REVISION TO DRAWING A1.0 — ROOF PLAN

END OF ADDENDUM 2

ROOF PLAN - DAYTON HIGH SCHOOL 1
T-10-C

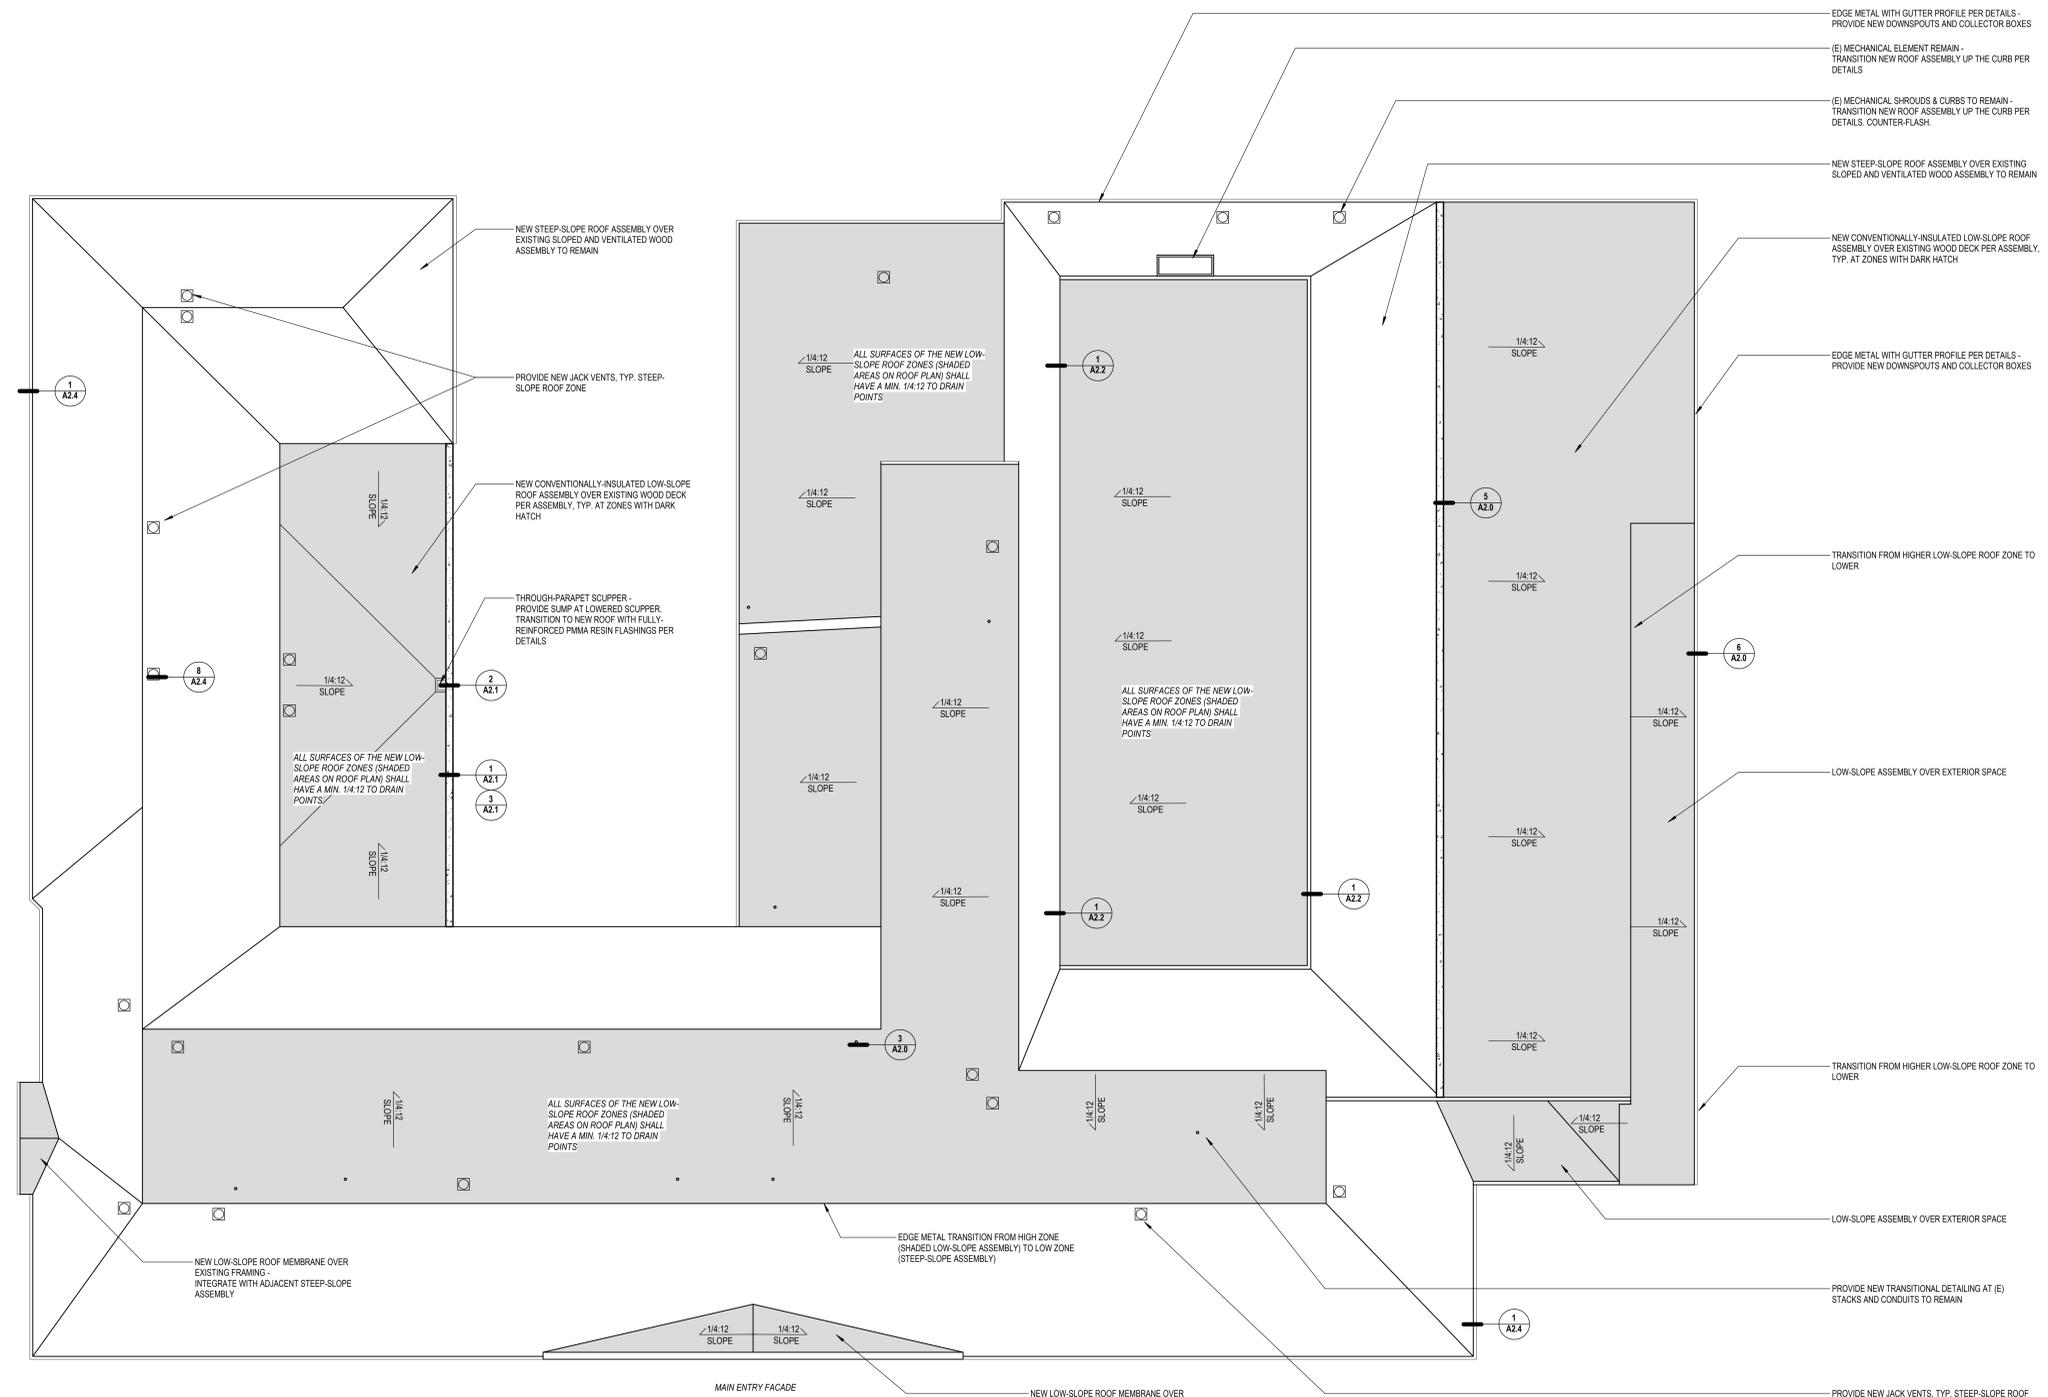
Disregard ***original*** DRAWING A1.0 – ROOF PLANE and replace with the **attached DRAWING A1.0 – ROOF PLAN in its entirety**.

Note: Roof scale added to drawings. We recommend Bidders to site verify.
